Re: Falcon Cove Beach Water District (PWS #00045) – New Well L132105 Curran-McLeod Project # 1530 Final Approval (PR #77-2019). SRF SD# 19-242

Page 5 of 10 Falcon Cove Beach Water District (PWS #00045) –Well L132105 Final Approval (PR#77-2019) December 9, 2021

APPROXIMATE LOCATION OF NEW WELL LATITUDE: 45.78815* ± LONGITUDE: -123.964701* ±

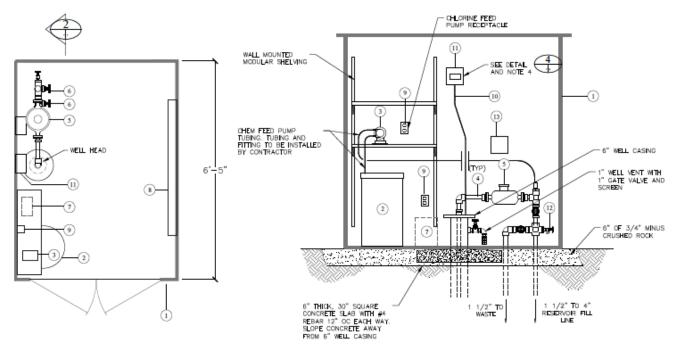
The project included drilling a new well to serve the District as shown below.
